SUBDIVISION REVIEW SHEET**CASE NO.:** C8-2018-0165.4A**COMMISSION DATE:** September 6, 2022**SUBDIVISION NAME:** Cascades at Onion Creek East, Phase Four**ADDRESS:** 11601 S. IH 35 SVRD NB**APPLICANT:** M/I Homes of Austin, LLC (William G. Peckman)**AGENT:** LJA Engineering (Russell W. Kotara, P.E.)**ZONING:** I-SF-2 (single family)**NEIGHBORHOOD PLAN:** n/a**AREA:** 22.34 acre (973,130 sf)**LOTS:** 110**COUNTY:** Travis**DISTRICT:** 5**WATERSHED:** Onion Creek**JURISDICTION:** Full Purpose**SIDEWALKS:** Sidewalks will be constructed along streets.**VARIANCE:** None**DEPARTMENT COMMENTS:**

CITY OF AUSTIN –DEVELOPMENT SERVICES DEPARTMENT
SUBDIVISION APPLICATION – MASTER COMMENT REPORT

CASE NUMBER: C8-2018-0165.4A
UPDATE: U2
CASE MANAGER: Cesar Zavala PHONE #: 512-974-3404

PROJECT NAME: Cascades at Onion Creek East, Phase Four Final Plat
LOCATION: 11601 S IH 35 SVRD NB

CASCADES AT UNION CREEK EAST, PHASE FOUR

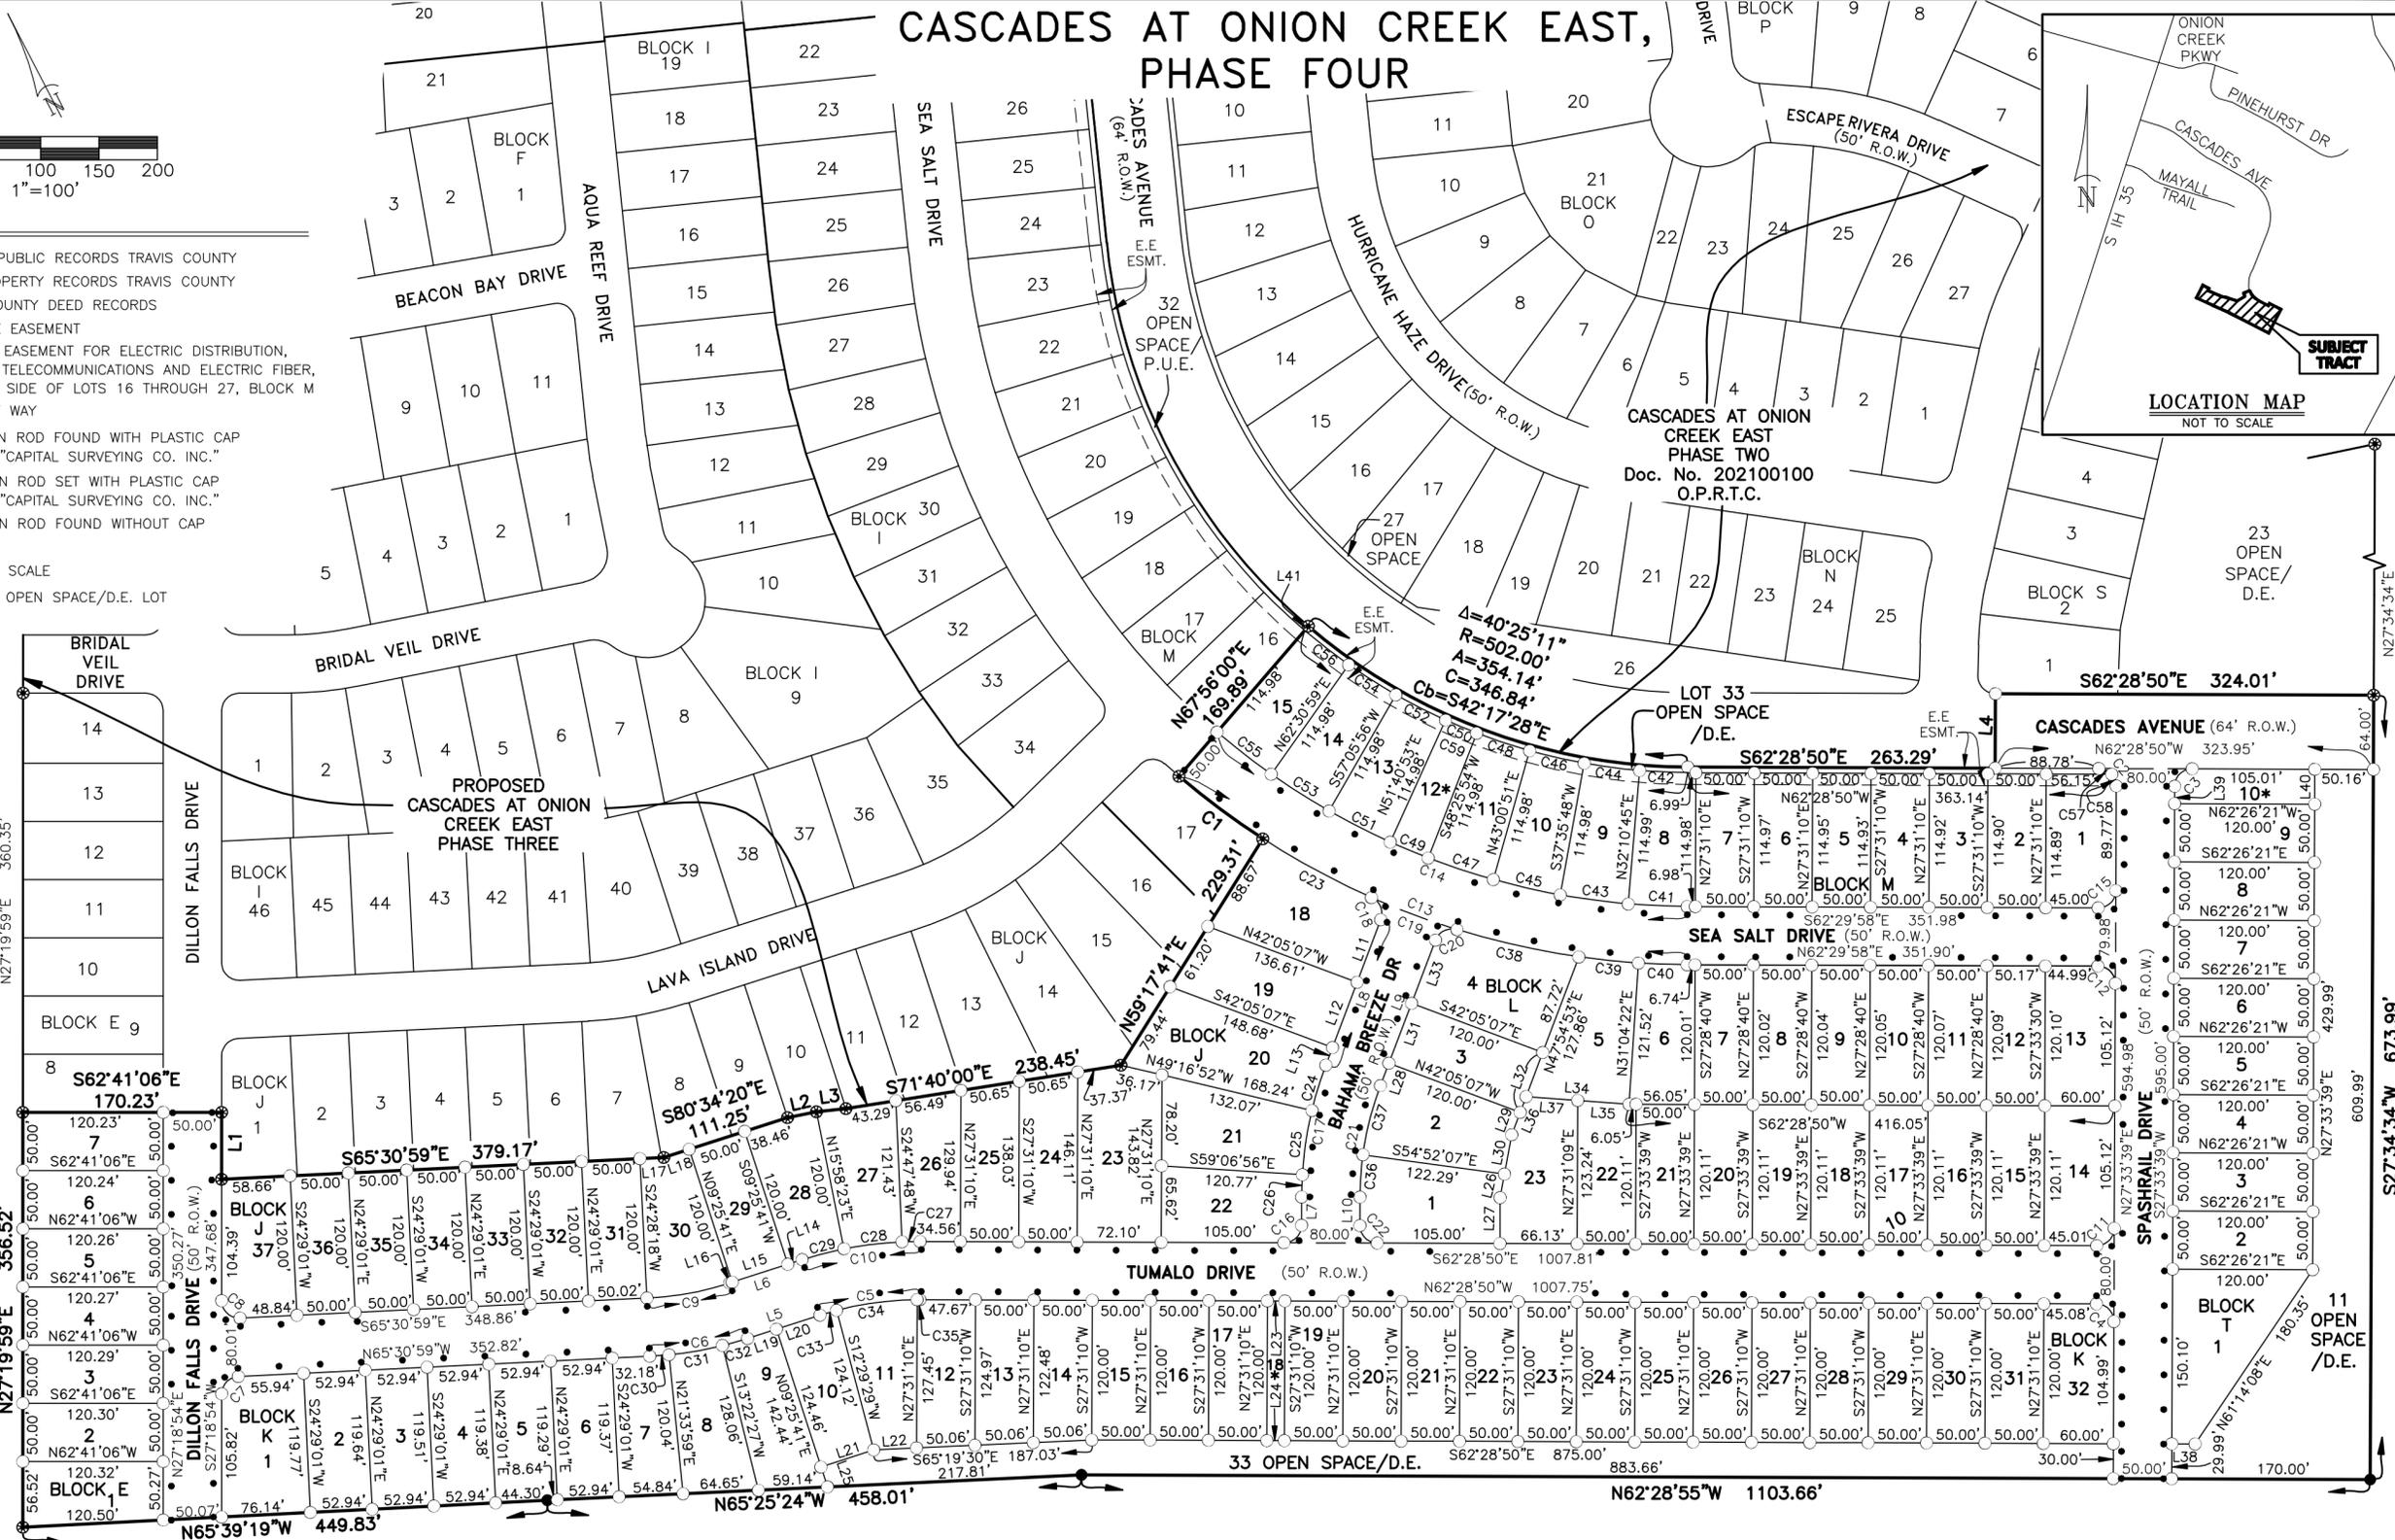
DE 6. CLEARED. Access provided with extended street to the property line.
